## **ATTACHMENT J-2**

### **RESPONSE LETTERS ON NOTICE OF PREPARATION (NOP), RESPONSE LETTERS ON SUPPLEMENTAL NOP, RESPONSE LETTERS ON NOTICE OF INTENT (NOI)**

#### **RESPONSES TO THE SUPPLEMENTAL NOP**

Mid-County Parkway and State Route 79 Interchange

Mid County Parkway Alternatives  
Lake Mathews

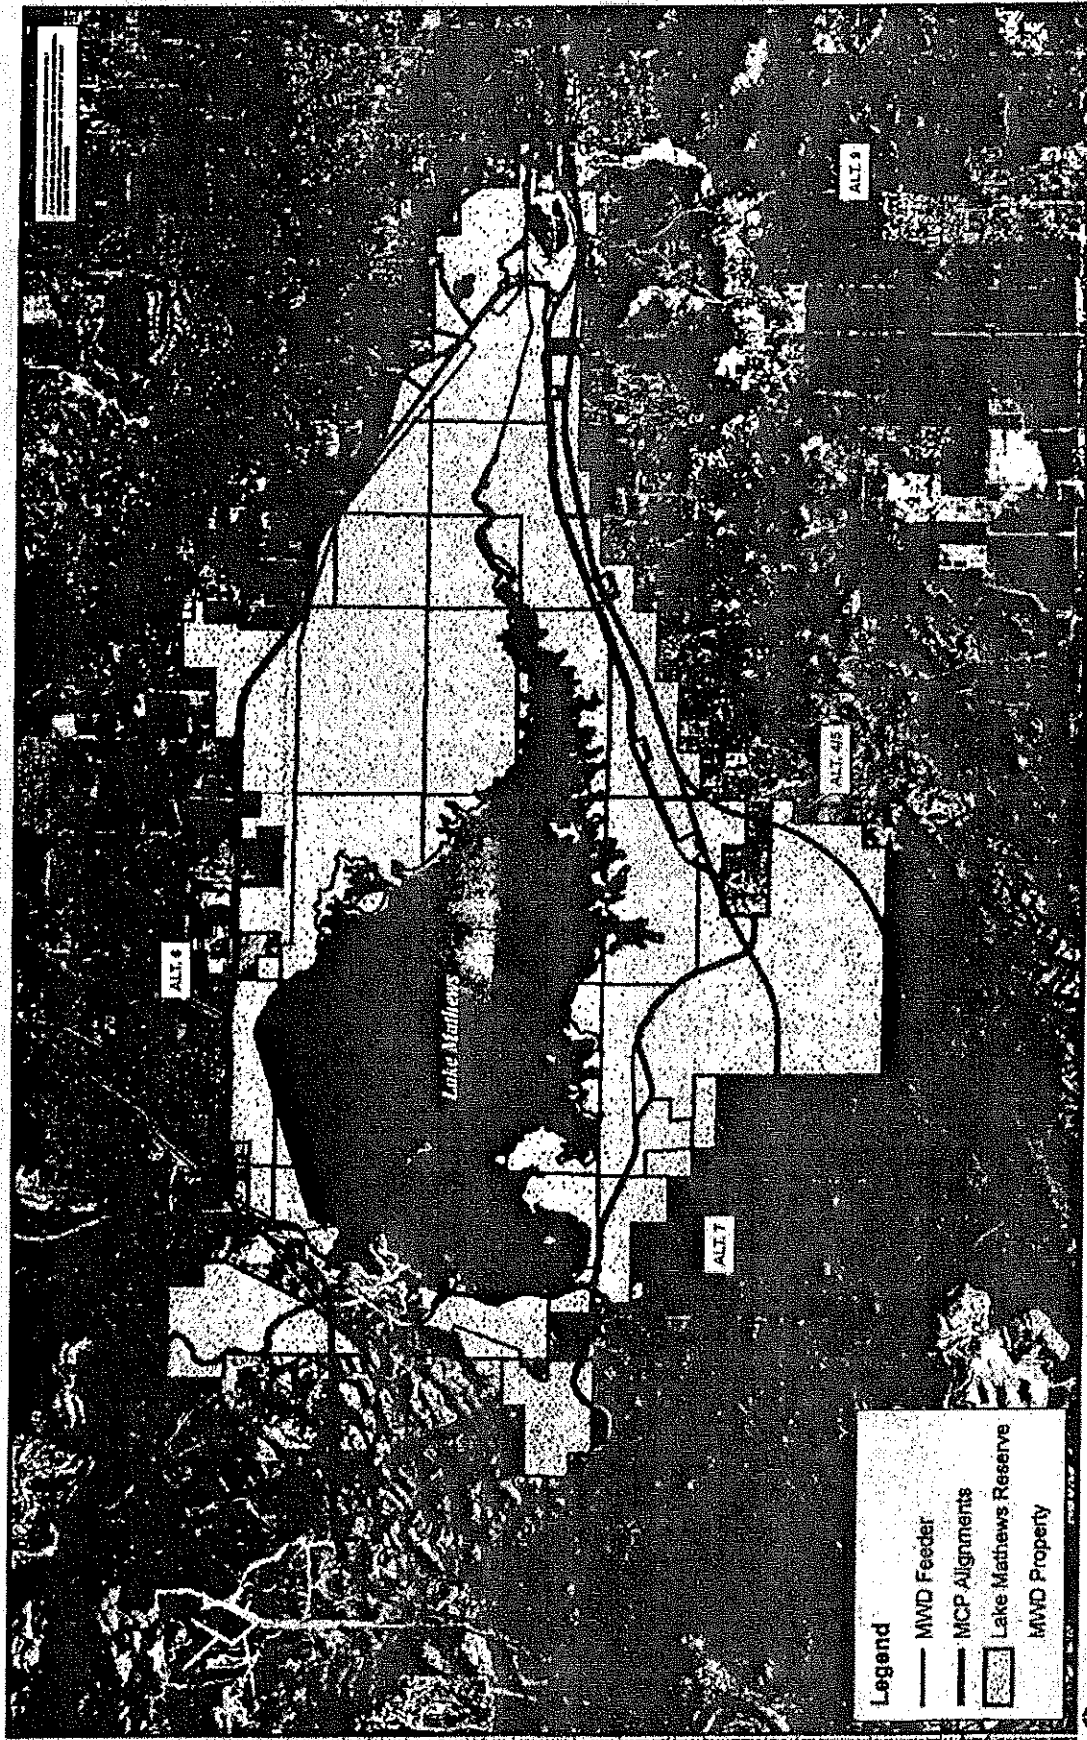
Metropolitan requests that RCTC choose an alignment that addresses these concerns by avoiding any impacts to the reserve and operational lands, and by avoiding or minimizing impacts to Metropolitan's facilities. Based on a review of the preliminary data provided by RCTC, only Alternative 9 (the southernmost route) avoids the reserve, and has the fewest impacts on Metropolitan's facilities. Enclosed for reference is a map showing the proposed MCP alignments, including Alternative 9, in relation to the reserve and Metropolitan's major facilities.

As we have stated repeatedly in the past, Metropolitan cannot support or sanction any alternative that enters or impacts the reserve in any way. The MSHCP/NCCP encompasses about 5,110 acres of land surrounding Lake Mathews, including the lands in the State Ecological Reserve. These lands are protected for their benefit to endangered, threatened or sensitive species and provide the basis for Endangered Species Act compliance for Metropolitan projects located in Riverside County.

Metropolitan is also concerned about impacts to its facilities and their operation, as set forth in detail in the enclosed correspondence. In short, all of the proposed MCP alignments, including Alternative 9, would impact Metropolitan facilities. In addition, all alignments have the potential to affect how these facilities are operated. RCTC must carefully analyze the potential impacts, including but not limited to those from increased lateral and vertical loading, induced settlement, impacts to operations of the facilities, and altered drainage patterns. See, for example, the enclosed September 28, 2006 and March 29, 2007 correspondence for more detail on this subject. Any proposals to realign or accommodate Metropolitan's facilities, including the costs of such accommodations, are potentially significant and should be analyzed in detail by RCTC. We welcome the opportunity to provide information relevant to this analysis upon your request.
